ADDENDUM NO. 3

DATE: June 5, 2019
FROM: City of Grand Junction Purchasing Division
TO: All Offerors
RE: Las Colonias Park – River Recreation Feature IFB-4648-19-DH

DRAWING NO.
C-01
 SHEET C-01 OF 24

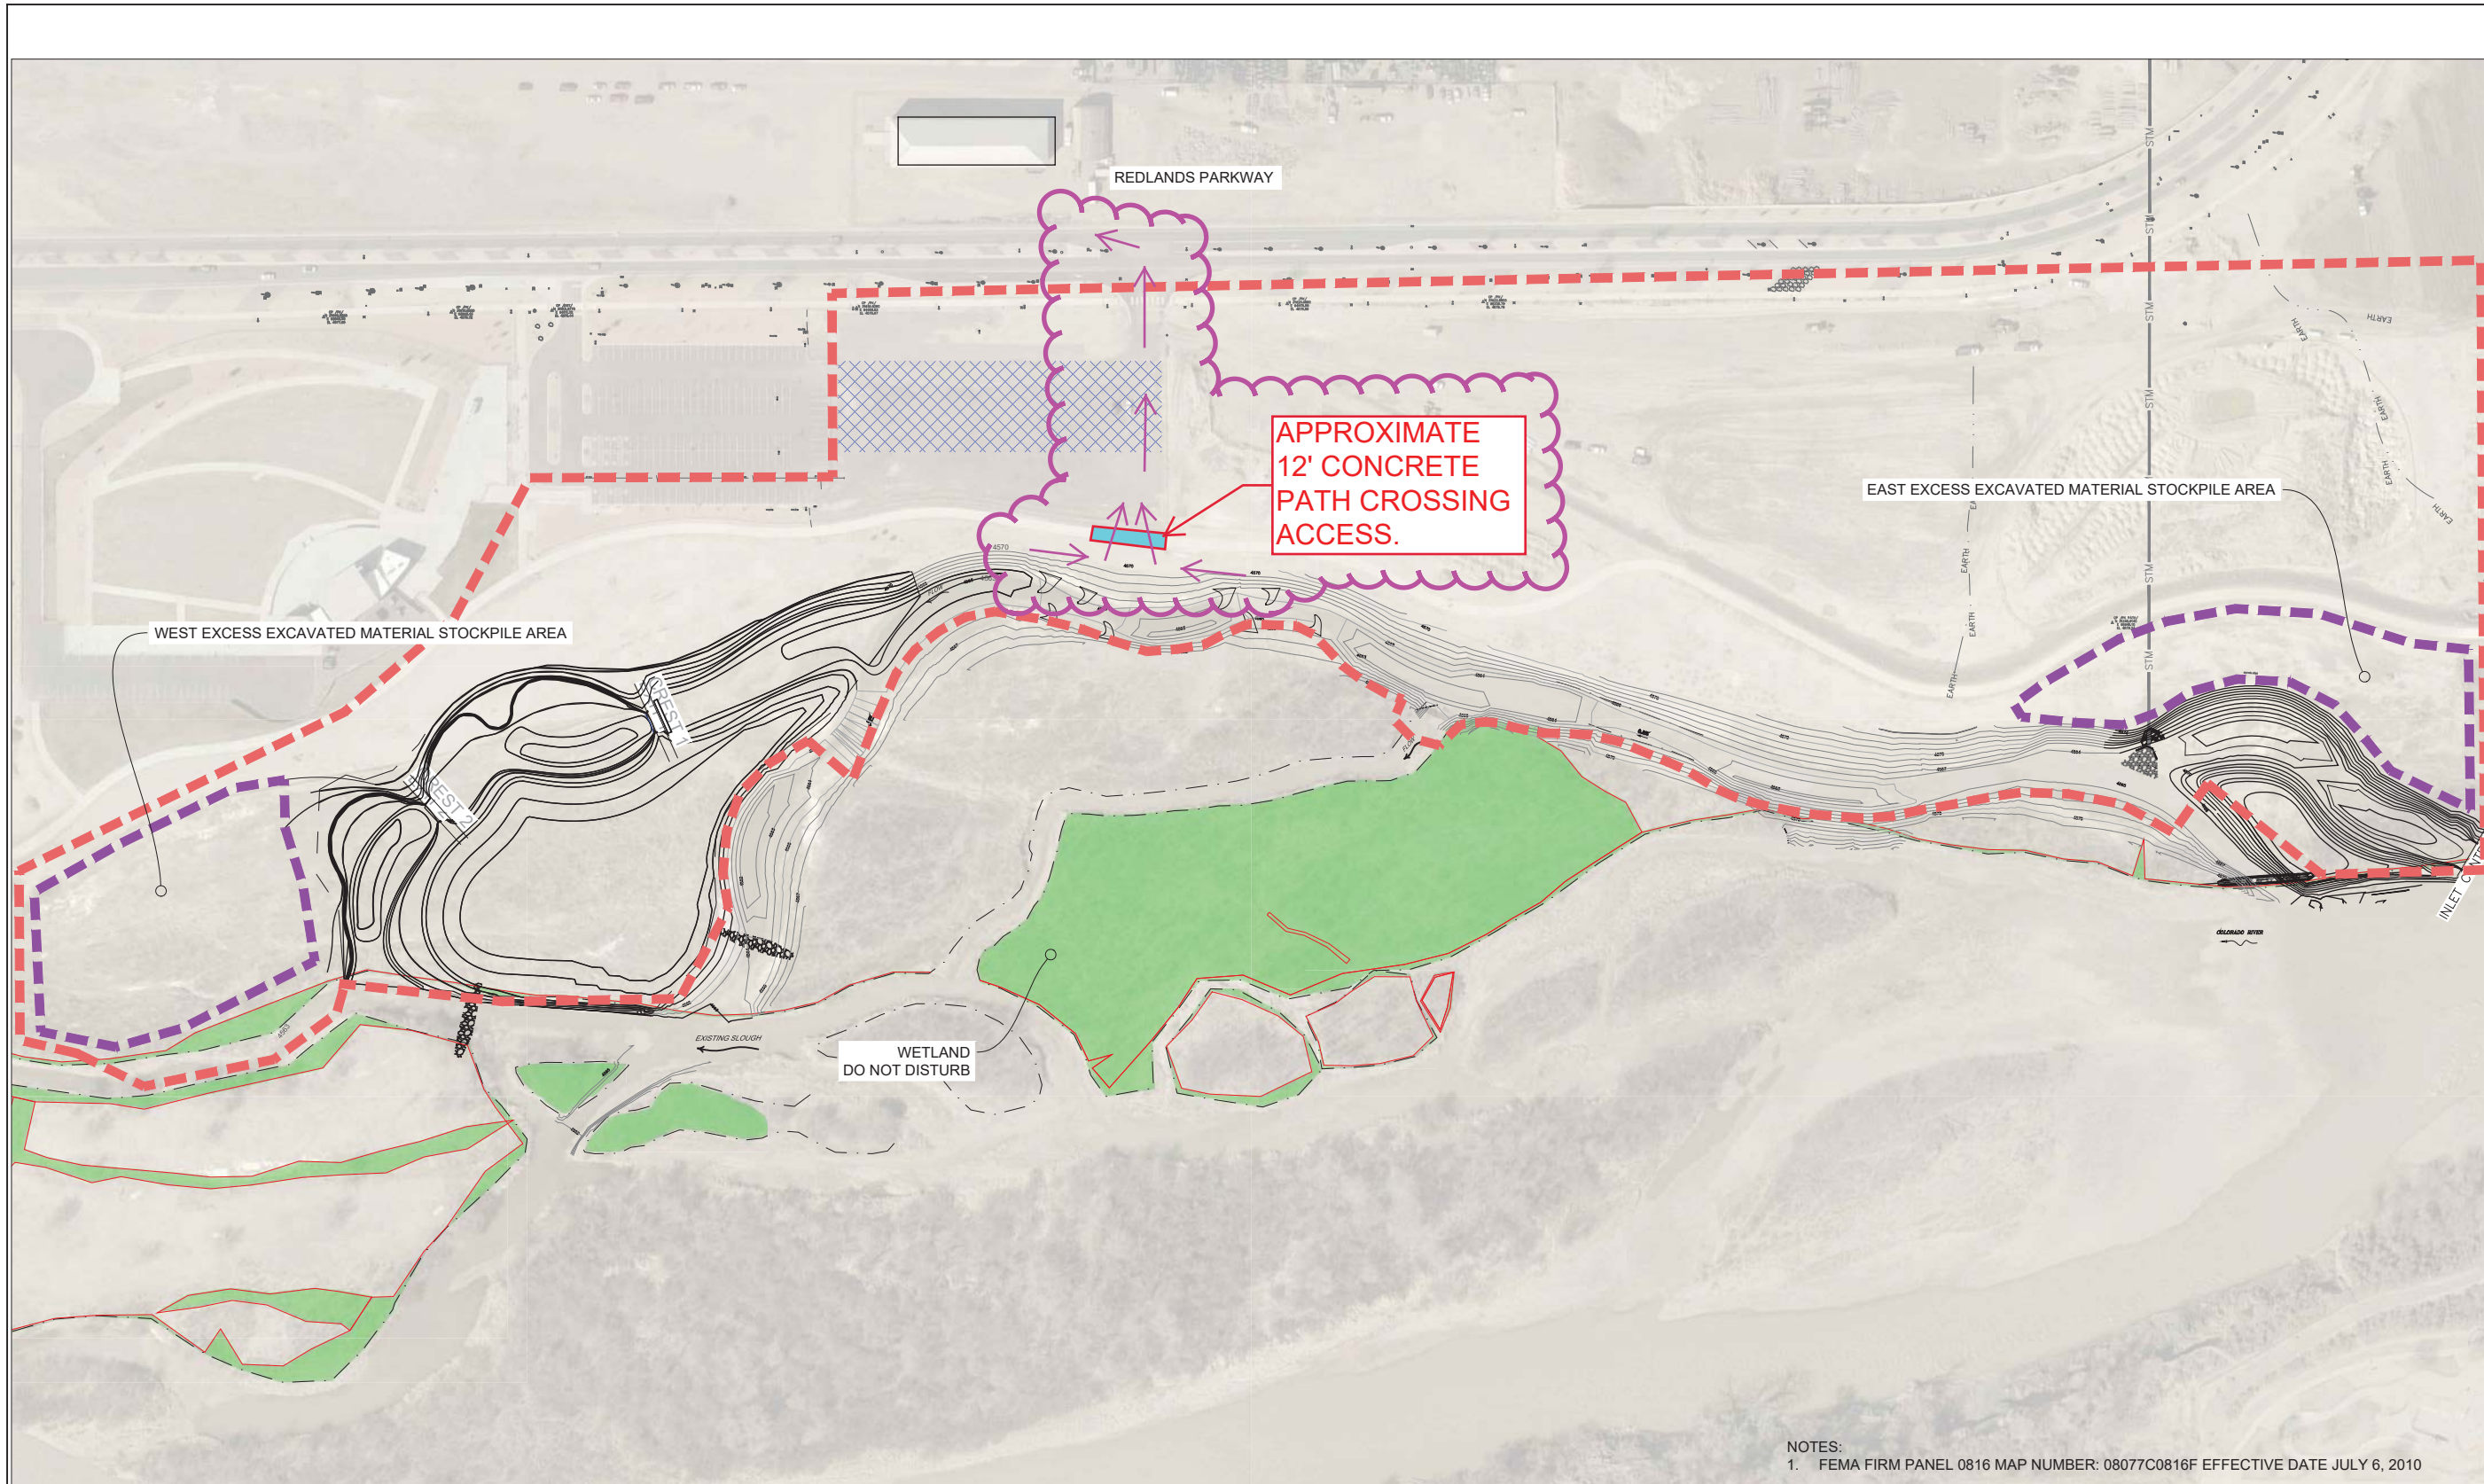
3. Q. Will there be a designated location for trucks crossing the existing concrete path?
This section of path will most likely need to be replaced. What line item should this be under?

A. *Yes. See attached exhibit showing the designated crossing of the existing 12-foot wide multi-use path. See line item #6 within the updated bid schedule.*
